**SUBJECT:** 988X and 989X PA Modification Kit, PN 250-9884-533

**Radio Models Affected:** High power (30W) 800 and 900 MHz radios with a date code before April 1, 1999 (139). The 30W high power model is identified by the "2" in the 5<sup>th</sup> character of the serial number. The date code is the 7<sup>th</sup> through the 9<sup>th</sup> characters. The 7<sup>th</sup> and 8<sup>th</sup> characters represent the week of the year and the 9<sup>th</sup> character represents the last digit of the year.

Board Assembly      Component Side      Solder Here      Q651      Back of Transceiver

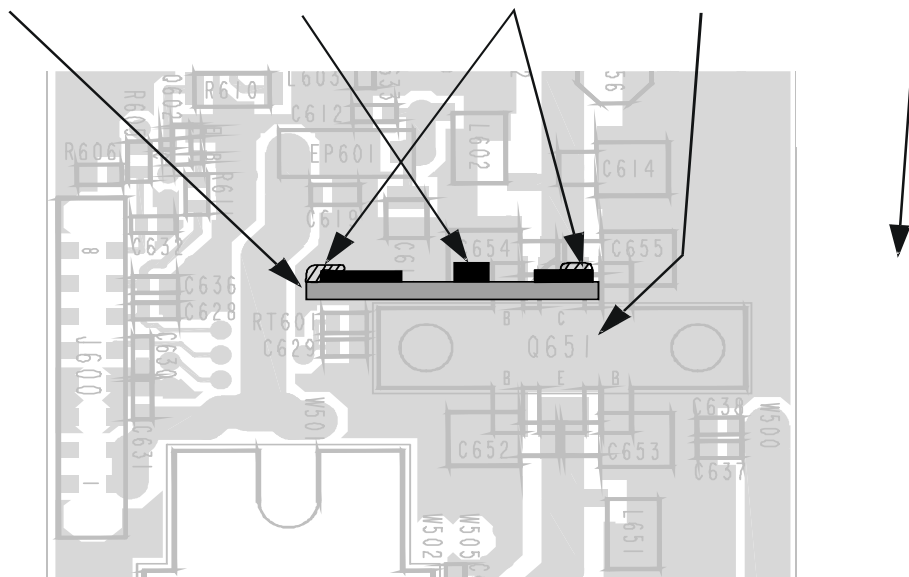
**Background:** Some early high power model 988X and 989X radios would exhibit a loud "squeal" while transmitting. Analysis revealed that VSWR instability was the source of the problem. A small PC board assembly was added to the PA to improve VSWR stability.

3. Position the PC board assembly from the kit in the location shown above. Make sure that the component side of the board is facing away from Q651.
4. Solder the tabs of the board to the collector and ground leads of Q651. The solder should wick up slightly on the board tabs.
5. Replace the shield cover. Transceiver retuning is not necessary after installing this board.
